PHOTOGRAPH #2

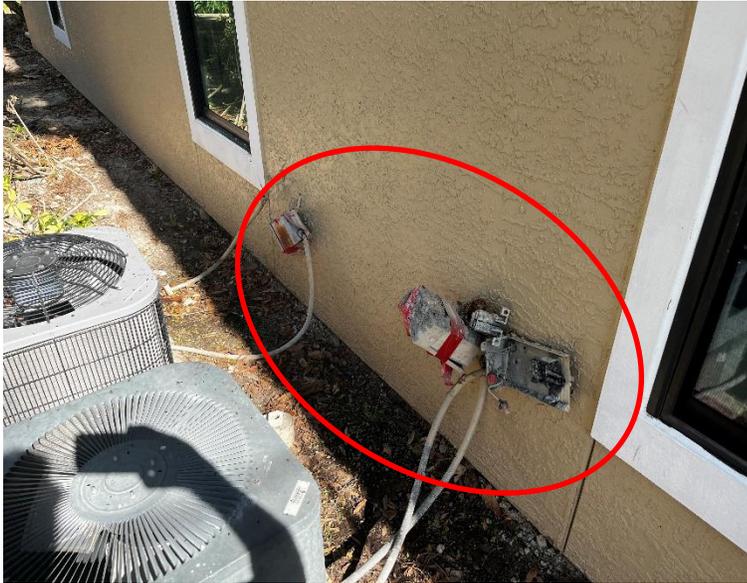
One #12 SMS installed at the head, thru the frame (similar to flange installation) as per PGT engineering letter and approval.

PHOTOGRAPH #16

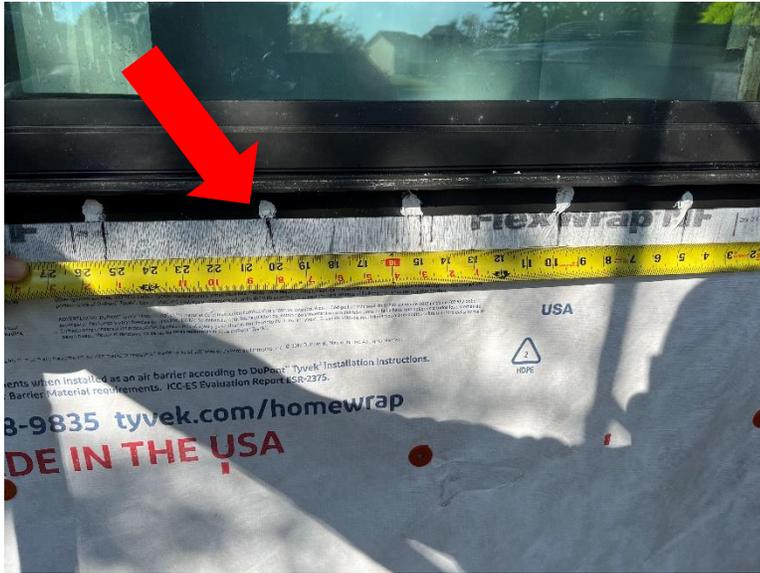
Stucco sub-contractor applying Henry Jumbo Tex 60 WRB and new vinyl stucco accessories as per drawings.

PHOTOGRAPH #17

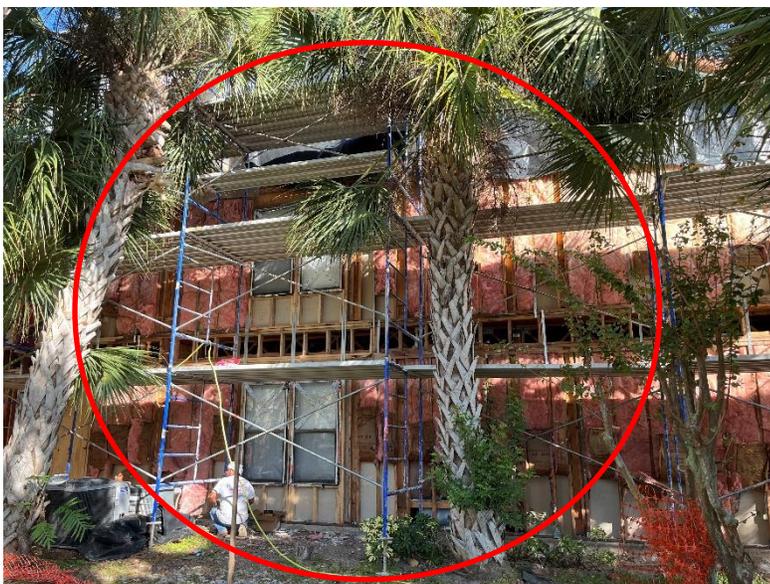
New PGT SH7700A single hung aluminum windows attached at flange to framing with 8d common nails at 5" O.C as per Manufacturer's NOA.
